TRINITY ISLAND SITE D

S73 (MMA) Supporting Document - Landscape Items

ZD-TPM-G710-RP-XX-512 - Revision P3
July 2024

Approved GA (Rev P5)

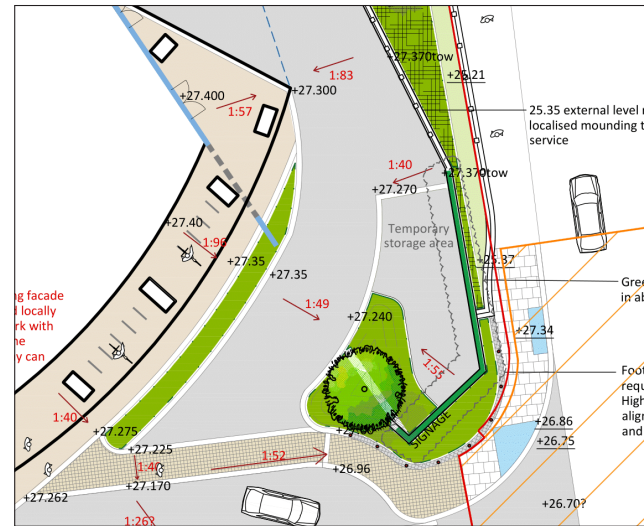
The updated planning drawing includes a number of minor changes which have become necessary since planning as the project has progressed through into construction. A brief summary of the changes is listed below with detailed commentary following on the subsequent pages.

- Minor boundary treatment change to Regent Road
- Provision of additional external bin store
- Removal of trees to riverside and re-provision of these within the site
- Inclusion of a dedicated dog park
- Creation of additional soft landscaping to river walkway
- Other minor layout updates such as the provision of vehicle management bollards.

SCREENED EXTERNAL REFUSE AREA

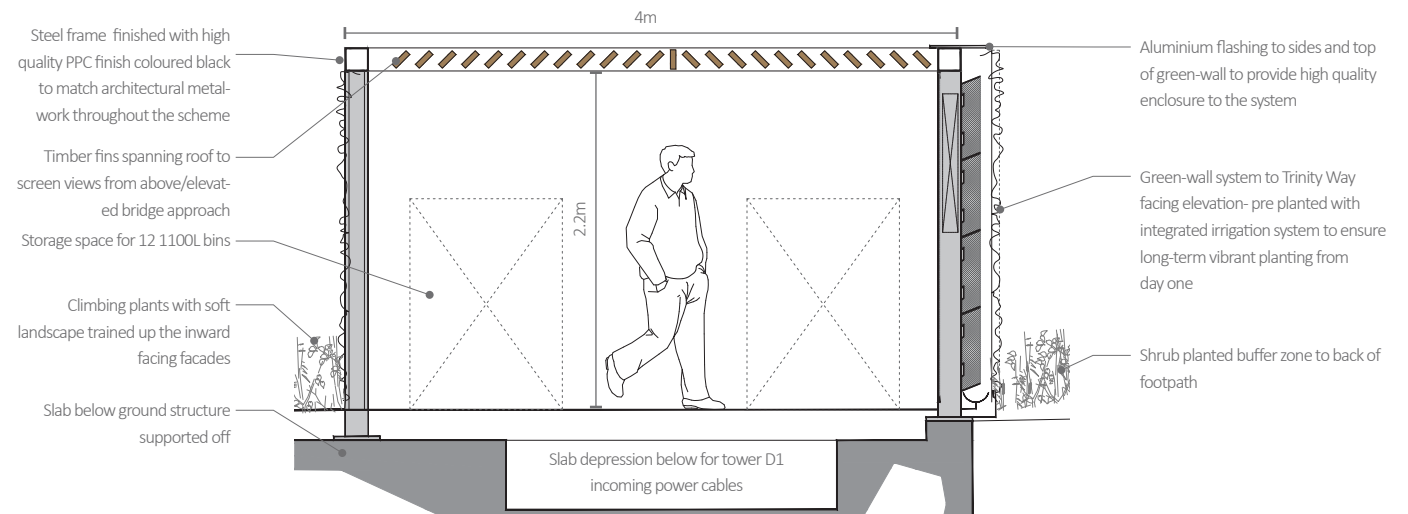
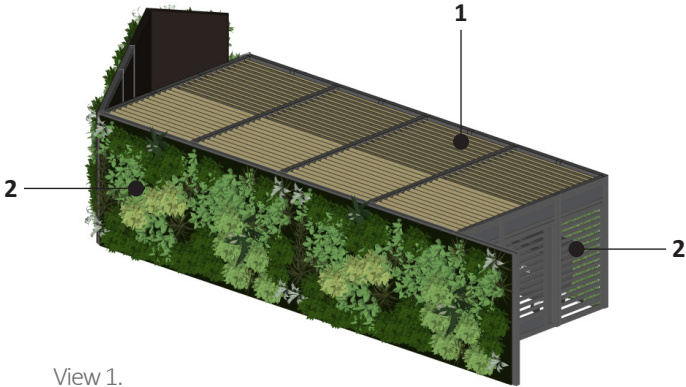
In the former generator position it is proposed to provide a screened external bin store. This additional storage area will allow for more flexibility easing congestion on collection days.

The area will be gated and designed to visually screen the bins from both ground level and apartment views from above. To the street facing elevation there will be a green-wall completely screening the enclosure behind (as per planning), the remaining three elevations and roof will consist perforate metal screening panels up which climbing vegetation will be encouraged to grow. Helping further to screen and soften the impact of the structure.

Climbing Plants Specification

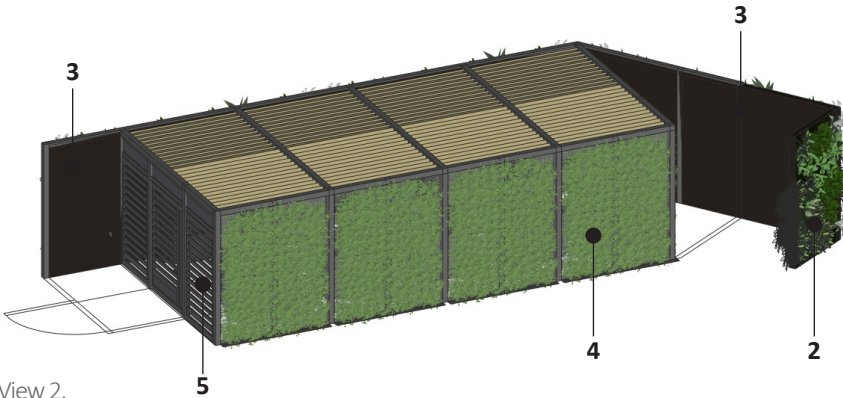
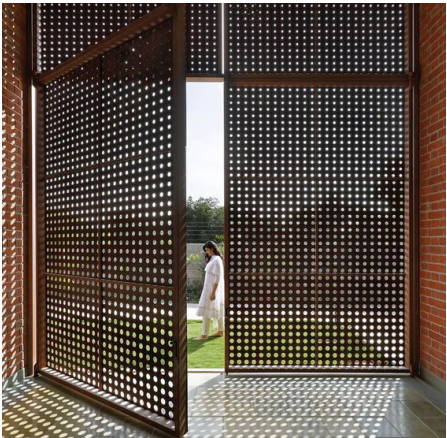
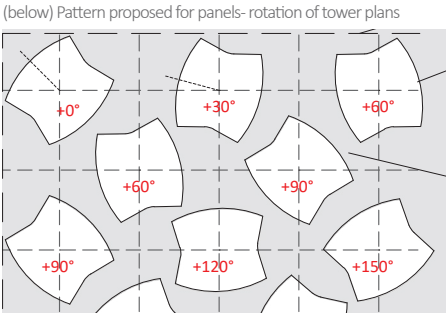
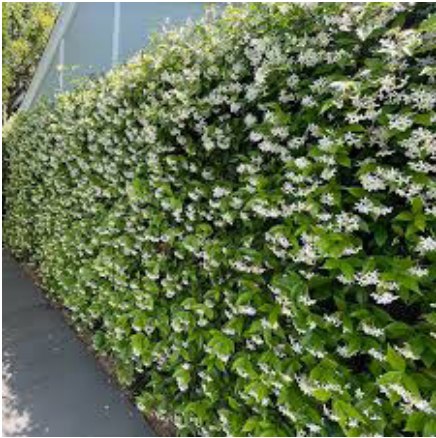
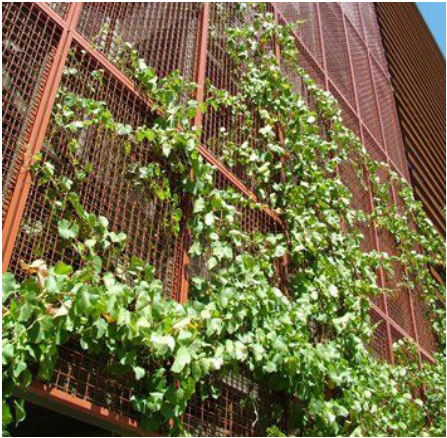
Trachelospermum jasminoides - Star Jasmine. 2-2.5m specimens have been specified to provide coverage to the whole elevation from the outset.

(above) Hardwood timber louvers to roof. Angled to obscure views from both the apartments above and elevated viewpoitns from the bridge approach

(above) Perforate metal doors- patter to match that of wind baffles across site.

Inward facing panels to be a mesh coloured to match the maine nclosure with climbing plants growing as screening

INCLUSION OF DOG PARK

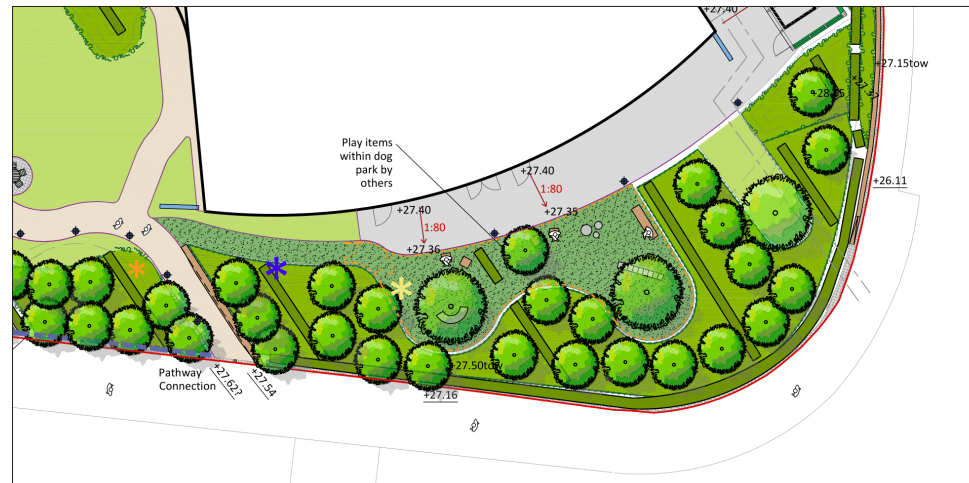
An area to the south of tower D2 has been redesigned as a dog park. This is in response to resident demand and a growing level of dog ownership within this type of development.

The park will be full fenced and double gated, provision is made for drinking water and play/exercise equipment. Dog waste bins and seats for owners are also proposed.

- Small reduction to extent of tarmac surface to building perimeter.
- Replacement of turf shrub planting for dog specific astro-turf surfacing.
- Break formed in hedge.

-  **Maintenance Water Tap**
Stainless column with lockable water tap
-  **Dog Park Water Tap**
Stainless column with self closing tap for users to fill dog bowls etc.
Client to confirm requirement.
-  **Proposed Balustrade to Dog Park**
-  **Proposed Low Maintenance Planting**
Mixed shrubs and native stock to create buffer
-  **Proposed Dog Specific Astro-turf**
Awaiting spec info from Zenith Management company

RIVER / REGENT ROAD RELIC WALL

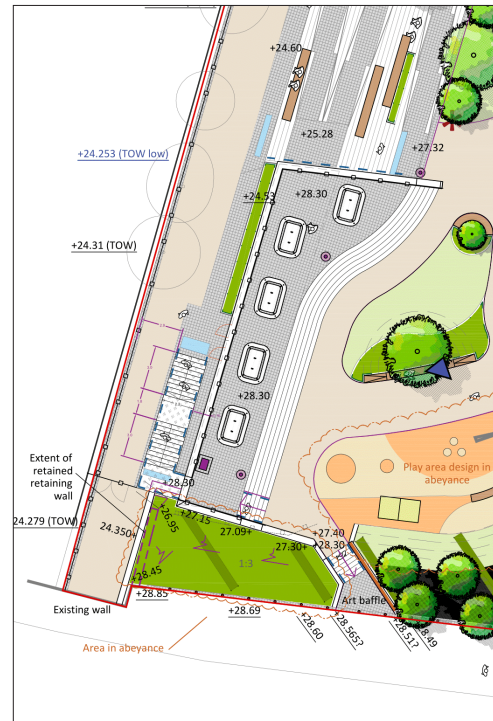
A minor layout change to the south west of site has been necessitated:

The condition of the existing masonry retaining wall is poor and the layout has already been amended to retain the relic structure.

Following detailed design of the new supporting structural wall, the requirements for foundations means the level of the existing top of relic wall is to be maintained.

This level is lower than that of the adjacent Regent road foot-way. The landscaping will be graded here but there will remain a level difference. A combination of replacement and new metal railings will be required to this boundary to provide fall restraint from the foot-way.

Four new trees are proposed to this area as part of the increased tree provision.

- Existing retaining structure retained and stabilised
- Additional tree planting
- Replacement/new railings to guard against level change

REMOVAL AND REPLACEMENT OF EXISTING TREES

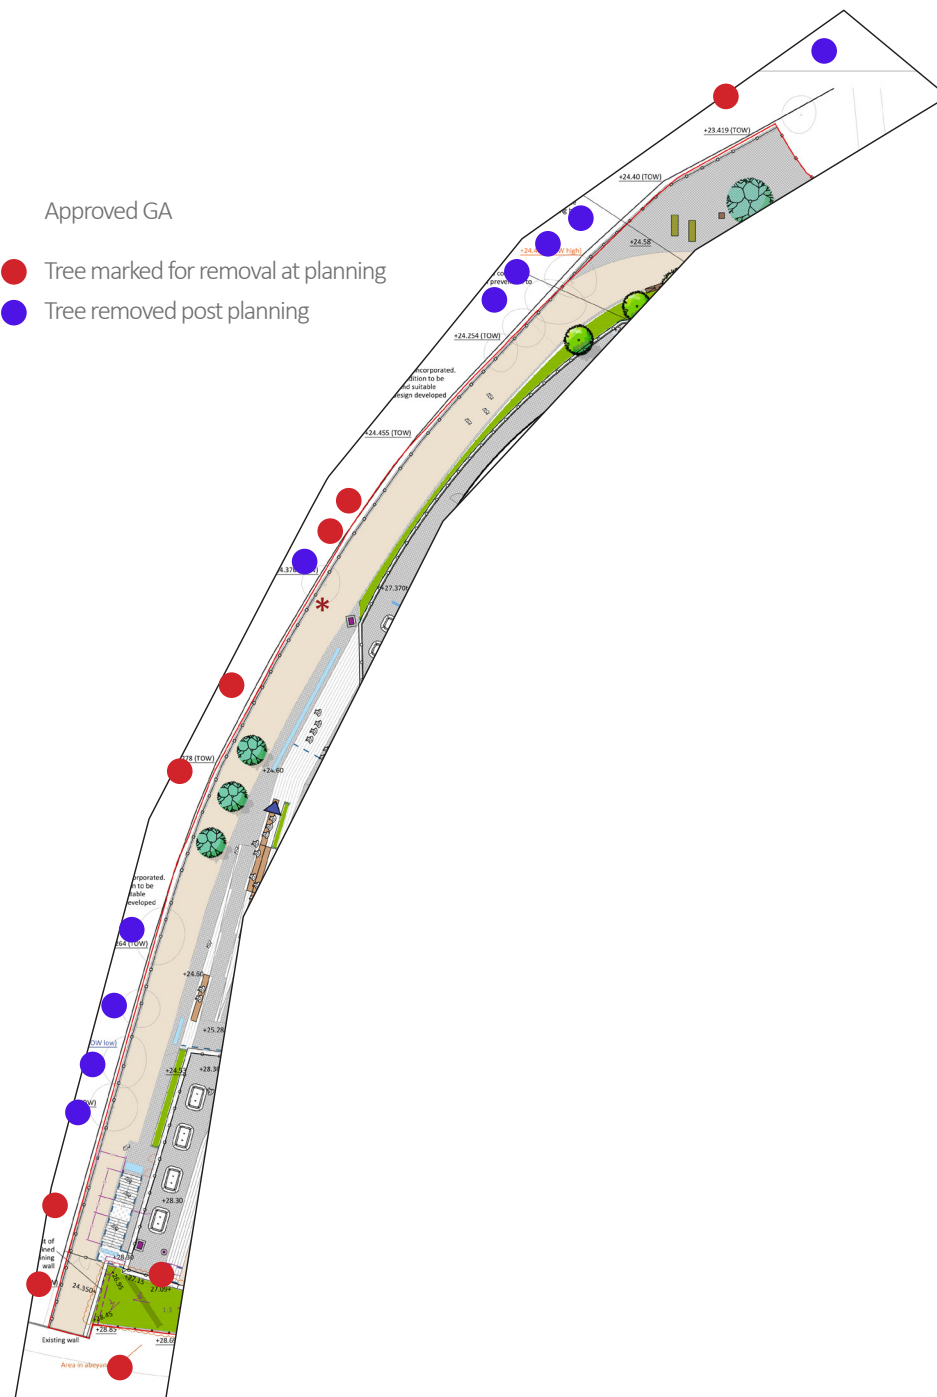
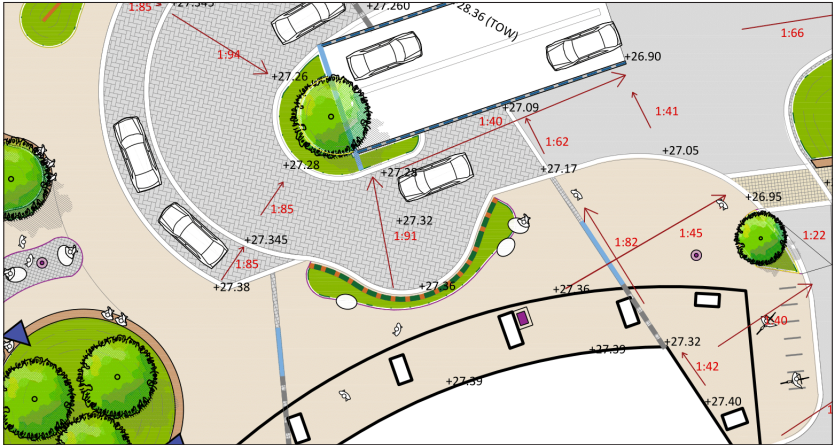
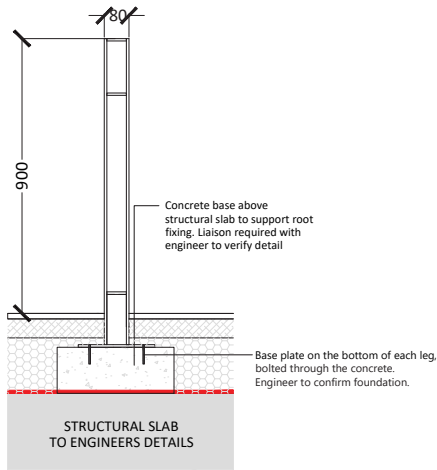
The additional trees we are seeking permission to remove number 10 in total and are all graded as category C specimens (trees of low quality with an estimated remaining life expectancy of at least 10 years, or young trees with a stem diameter below 150mm).

Growing on the rivers edge, the roots of these 10 trees have embedded themselves within the masonry of the river wall. The risk of root damage to walls is large and well known, particularly in retaining structures such as this. The retention of these trees would put at risk the long term stability of the river wall.

The approach is to remove the trees now and undertake necessary repair works whilst good access is afforded to the rivers edge for the equipment and personal required. To complete the planned works, a new concrete coping will be built to the length of the development which would provide the solid base for a new balustrade running to the length of the rivers edge.

The proposed GA incorporates the replanting of a further 10 new trees within the site, which in combination with the over provision of replacement trees at planning stage is proposed to mitigate the loss. Further information has been provided on the next page.

ADDITION OF BOLLARDS

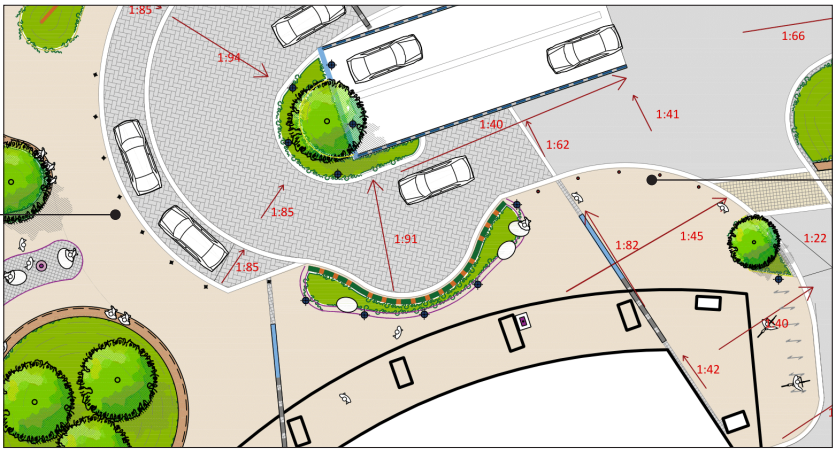
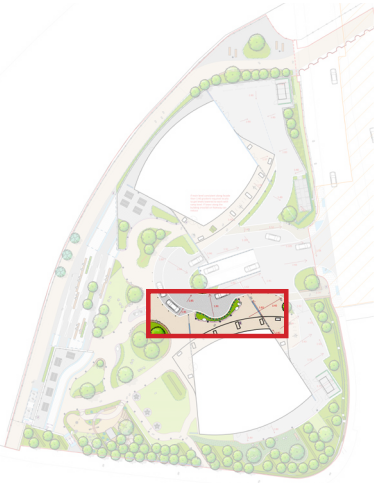
Bollards have been added to the scheme for building and pedestrian protection.

To the edge of the roadway within the site bollards have been placed to prevent cars from parking on the pavements. There is also the foundation provision made now for the potential extension of these bollards around the drop off zone should vehicles mounting the kerb become an issue in the future.

Bollard Specification:
Product: Moka Bollard
Supplier: Artform Urban
Finish: Stainless steel 316

ADDITION OF BOLLARDS

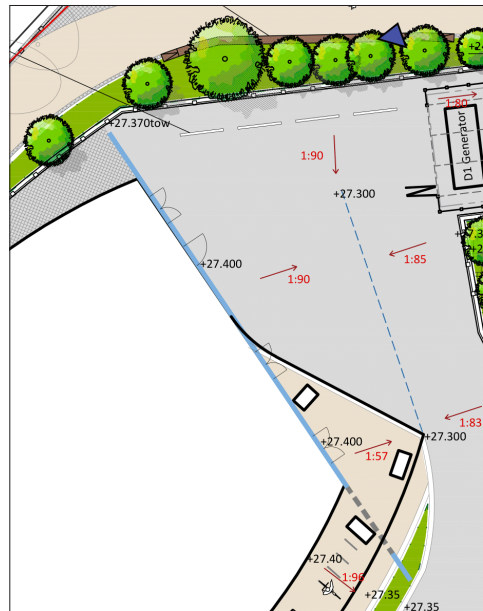
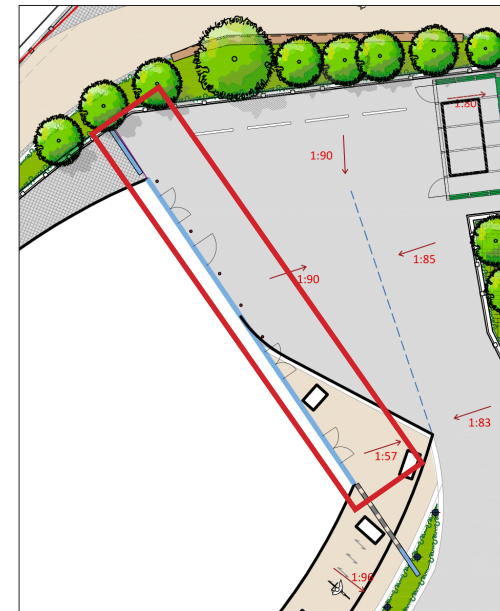
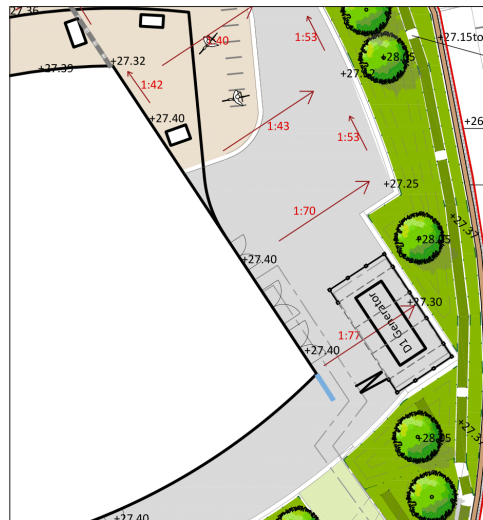
Alongside both towers bollards are added to ensure the building and facade is protected against any potential strikes from turning bin lorries.

ADDITIONAL SOFT LANDSCAPING

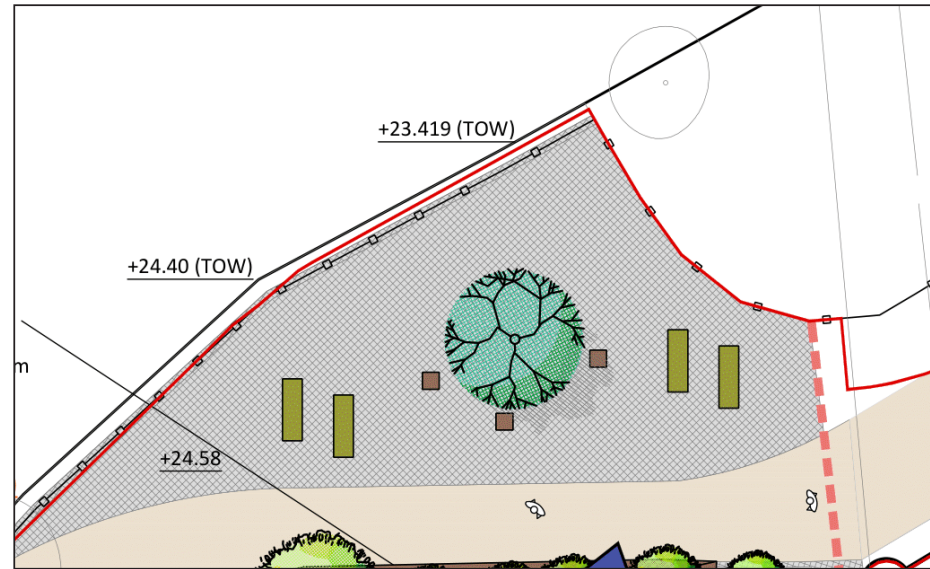
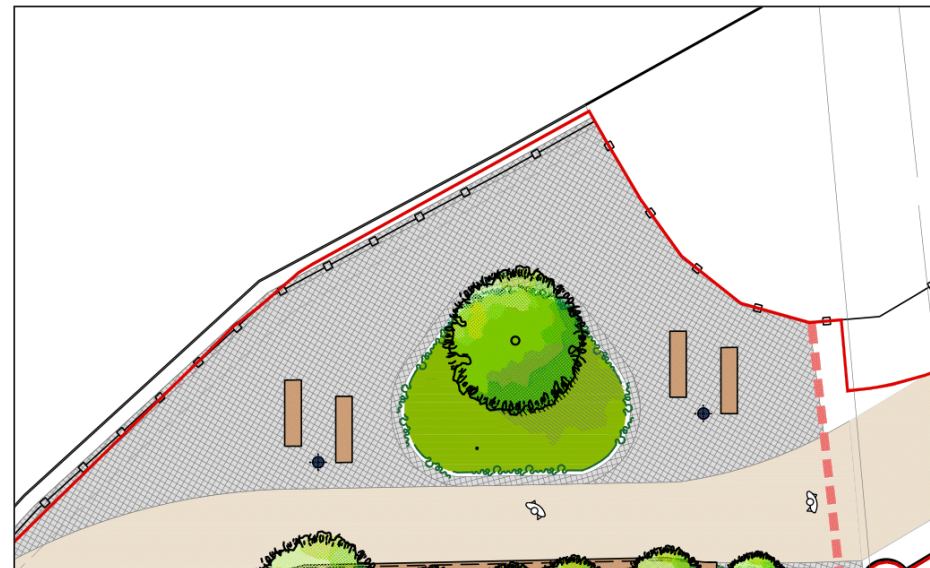
Adjacent to the onward connection with the bridge underpass an extra area of soft landscaping has been incorporated. The primary reason for its inclusion is to conceal a low level vent pipe that rises from below ground in this location.

But the benefits are far greater, the introduction of planting here breaks up a large area of hard standing and creates a more inviting spot to sit along the river.
